ADDENDUM – INVITATION TO TENDER  
FOR  
INDIAN HEAD RESEARCH FARM  
CONTRACT NO. 22 – BUILDING RENOVATIONS  
CONTRACT #465-1-4-C22

Addendum No. 2

**Project** : Indian Head Research Farm Maintenance Building B017 Remodeling  
**Project No.** : 4748  
**Date** : March 16, 2015

# M6.4

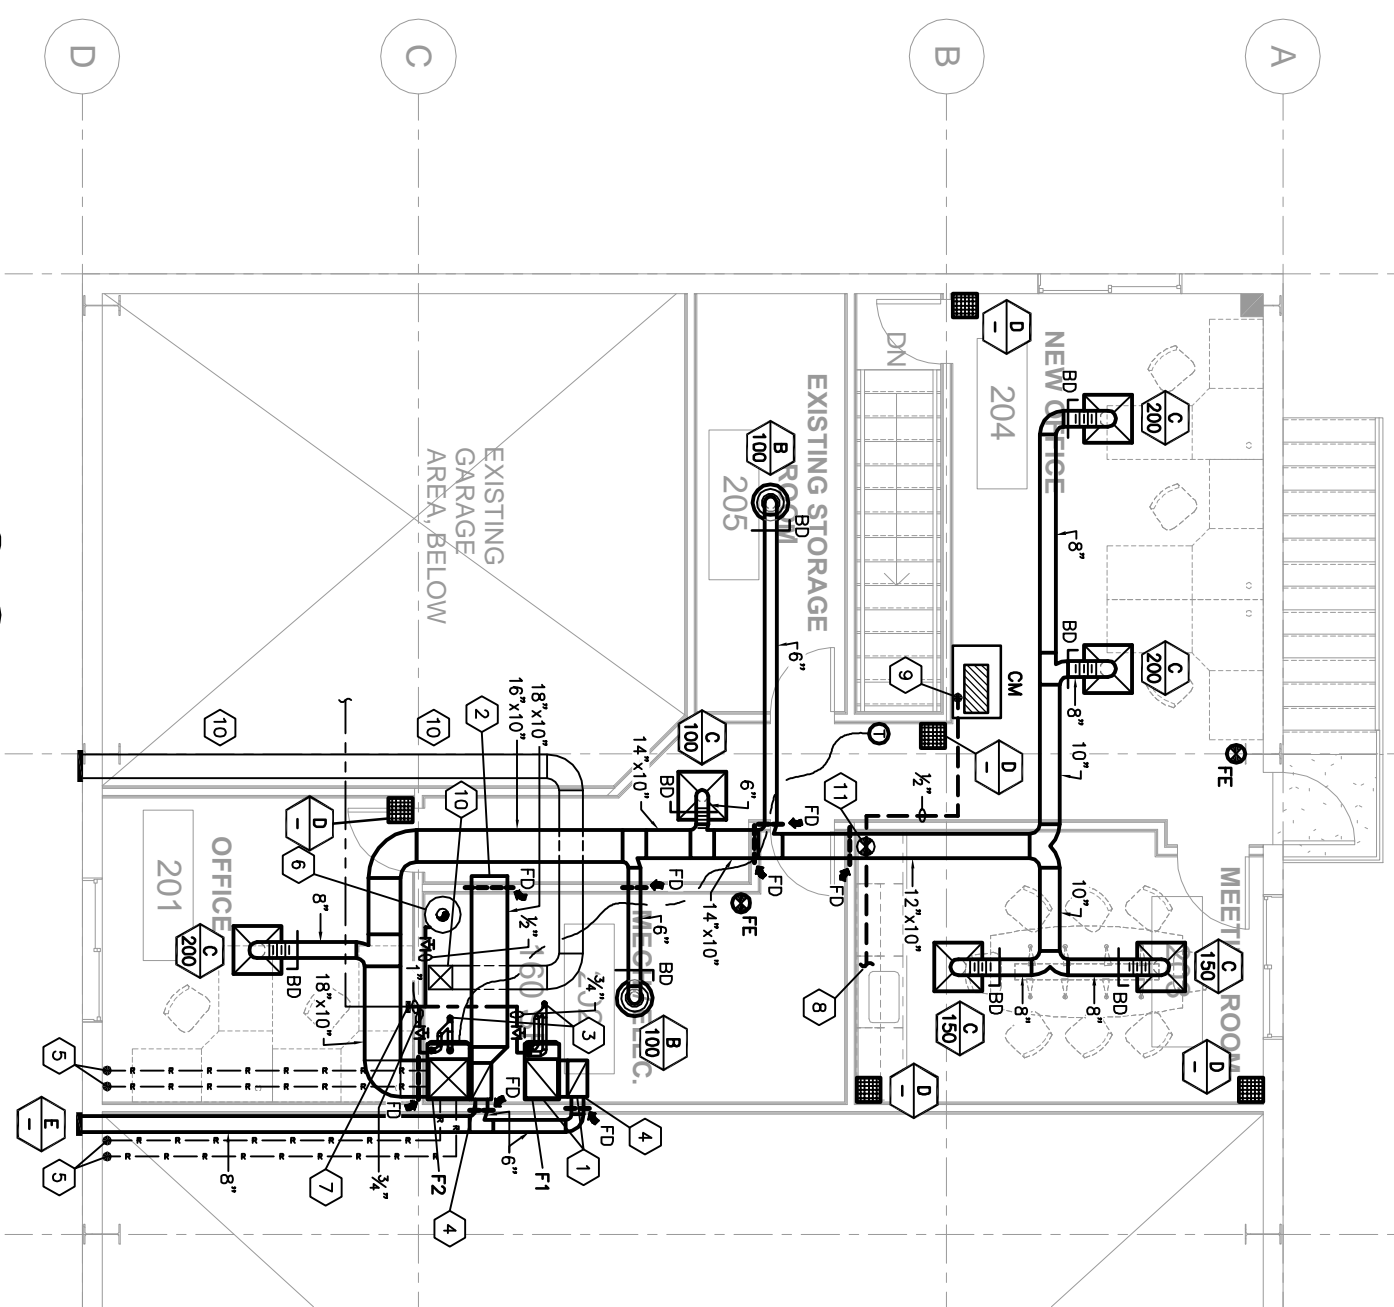
1. Replace Mechanical Drawings Sheets M6.2 through M6.4, with the Updated Drawings issued under this Addendum No. 2. NOTE: additional clarifications have been added on each one of these two mechanical drawing sheets.

MECHANICAL  
1. RESEARCH FARM MECH. ROOM EXHAUST DUCT.  
1. MARCH 16, 2015
